METROPOLITAN GOVERNMENT OF NASHVILLE AND DAVIDSON COUNTY

STAFF RECOMMENDATION
1114 North 14th Street
August 20, 2014

Application: New construction-addition & outbuilding
District: Eastwood Neighborhood Conservation Zoning Overlay
Council District: 06
Map and Parcel Number: 08301032100
Applicant: Peggy Newman
Project Lead: Paul Hoffman, paul.hoffman@nashville.gov

Elevations

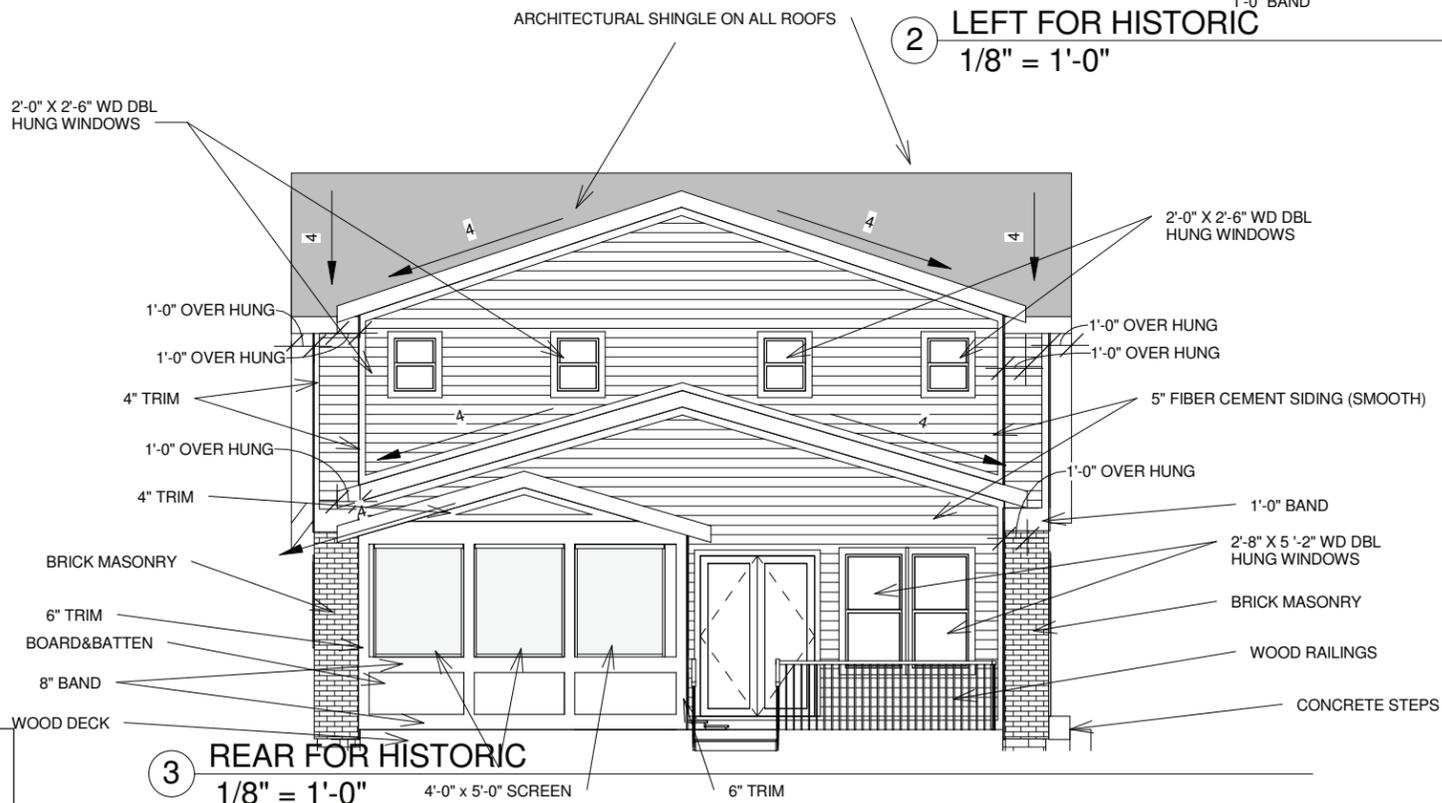
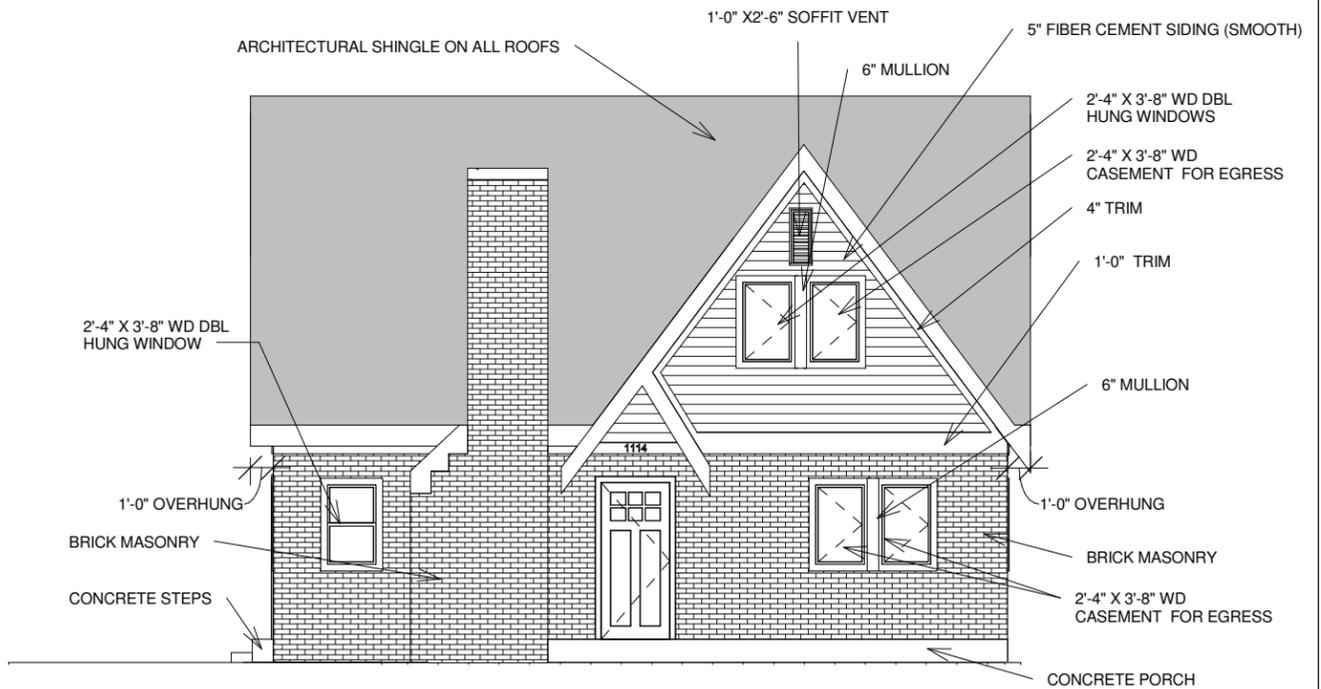
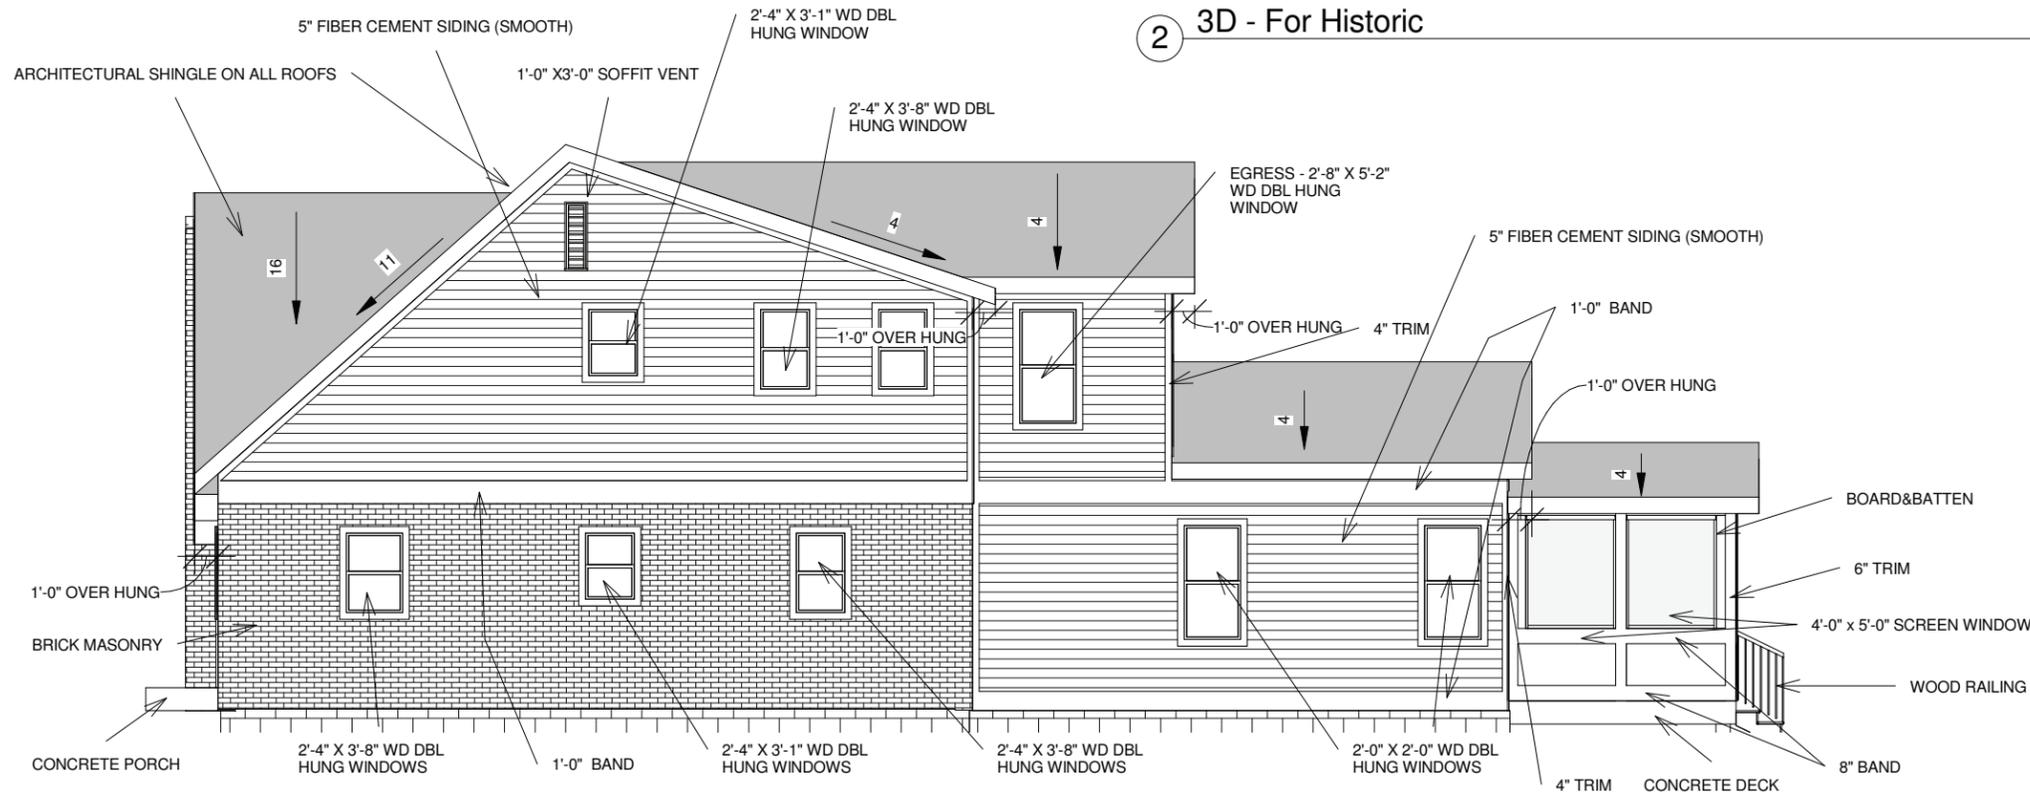
Height & Scale: The addition will set in two feet (2') on each side for a total width of twenty-eight feet and one inch (28'1"). The existing house is brick to grade. The addition will go to grade and will have a one foot (1') trim board at the foundation height. The eave height will match that of the house. The addition will add twenty-three feet and three inches (23'3") of depth to the house's existing thirty-two feet and eleven inches (32'11"). It will add a footprint of approximately six hundred and fifty-four square feet (654 sq. ft.) A screened porch and deck will add another ten feet (10') to the rear. The project meets section II.B.1.a.and b for height and scale, and II.B.2 for additions.

Roof form: The addition's gabled roof form is common in historic districts. The 4/12 roof pitch is the same as the rear roof of the house.

The project proposes the alteration of the historic design of the roof by adding a one foot overhang. Overhanging roof eaves are not common of this type of historic building and this era of historic construction. Staff recommends that the original roof design remain as it is. The project meets section II.B.1.e.

Proportion and Rhythm of Openings: The applicant is proposing to add two windows to the left side of the existing house, toward the rear. In this minimally visible location, the proposed windows will not significantly impact the historical character of the house. The windows on the addition are generally twice as tall as they are wide, thereby meeting the historic proportions of openings. The door opening on the left side of the house will remain as a doorway, but will not be used. The awning over that side door is falling off the house currently, and is proposed to be removed. The longest expanse of wall space without a window or door opening is nine feet (9') on the right side. Staff finds the project's proportion and rhythm of openings to meet Section II.B.1.g.

- The proposed one foot (1') overhang be removed from the plans to maintain the existing eaves of the historic house;
- Staff approve the dimensions and details of windows and doors, and the color of the roofing material;
- HVAC shall be located at the rear of the house, or on a side façade beyond the midpoint of the house, if a new location is needed; and
- The driveway be two concrete strips.

Garage for Historic		H5
Project number	Project Number	
Date	8/7/2014	
Drawn by	Yohana A.	
Checked by	Checker	
Scale 1/8" = 1'-0"

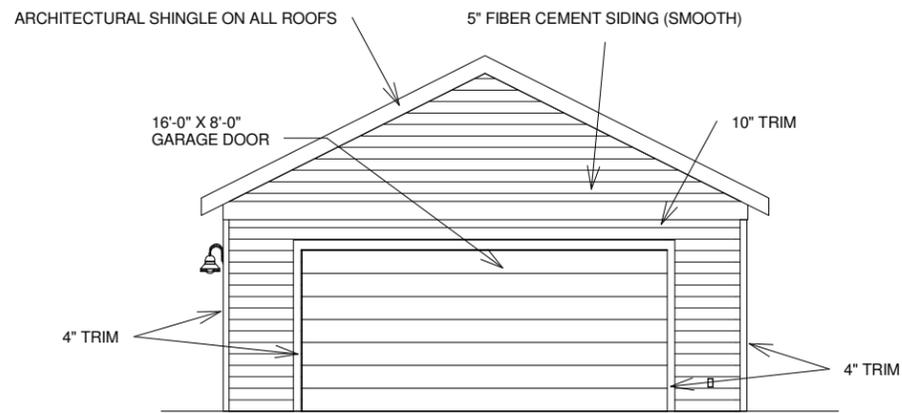
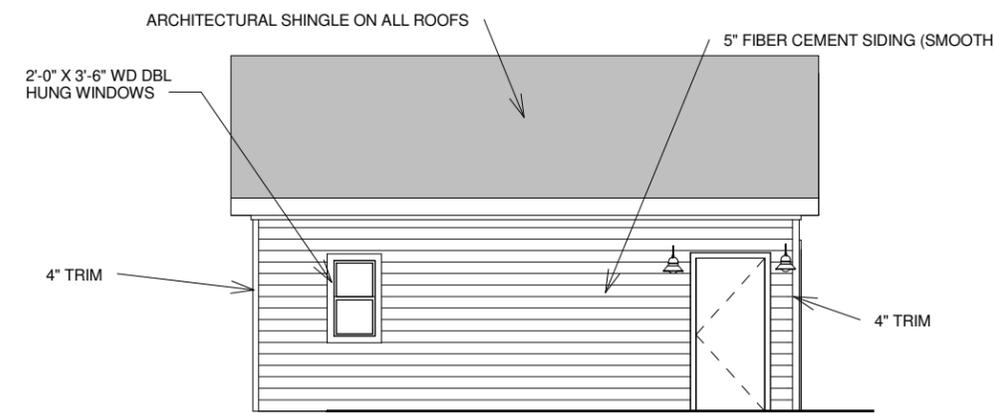
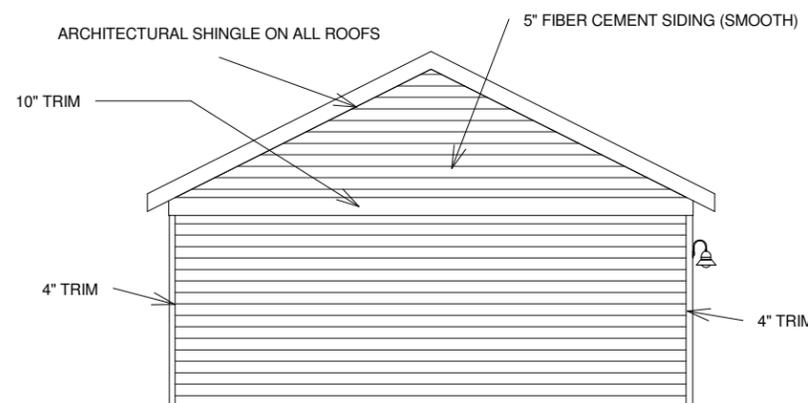
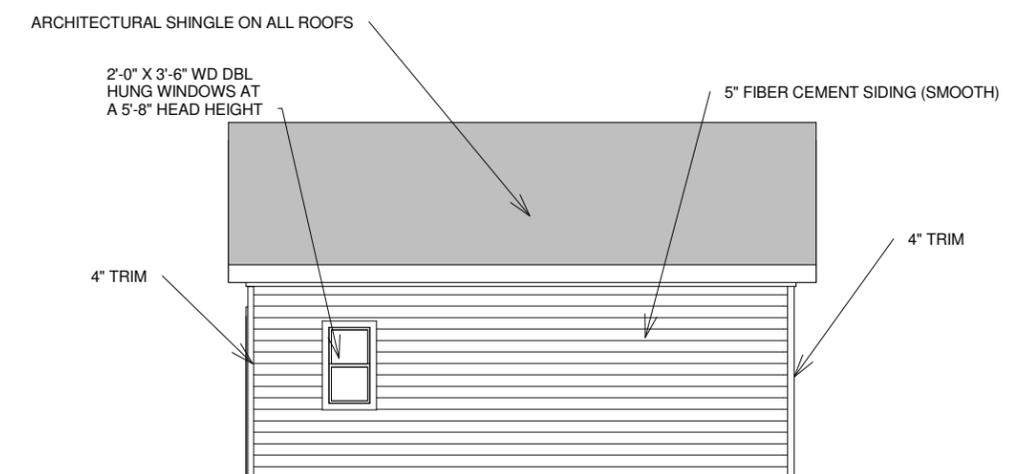
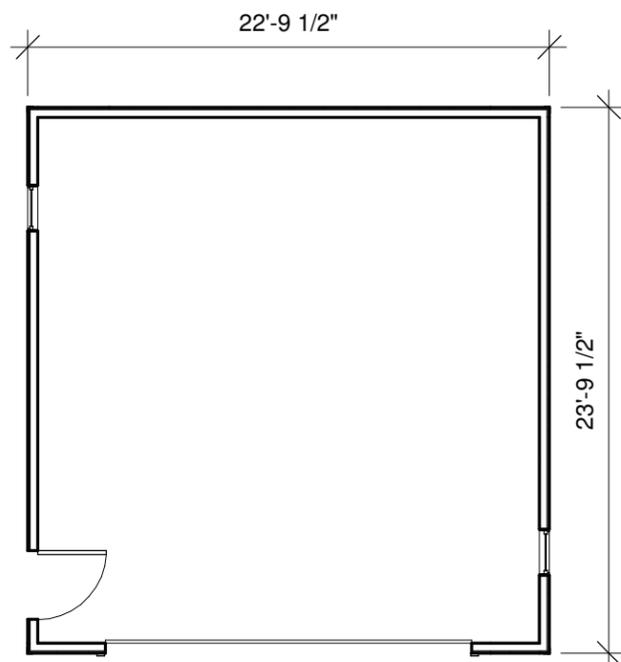
Outbuildings: The proposed outbuilding will be a one-story garage. It will be twenty-three feet nine inches (23'9") by twenty-two feet nine inches (22'9") for a footprint of five hundred and forty-two square feet (542 sq. ft.). It will be fifteen feet, six inches (15'6") tall. Its eave height will be nine feet (9'), compared to the ten foot (10') eave height of the house. Its ridge height will be fifteen feet, six inches (15'6") compared to the twenty-five foot (25') ridge of the house. Its location at the rear of the lot is appropriate for an outbuilding. The outbuilding will be accessed via a driveway from the street. Its gabled roof and 6/12 pitch are common in historic districts.

The materials include fiber cement siding with a five inch (5") reveal, wood or fiber cement trim boards, and architectural shingles. The drawings submitted indicate the outbuilding will be siding to grade.

The outbuilding will be located five feet (5') from the left side, twenty-two feet (22') from the right side, and twelve feet, two inches (12'2") from the rear property line, meeting setback requirements. With the condition that the outbuilding have two separate garage doors rather than one large one, the project will meet section II.B.1.h of the design guidelines.
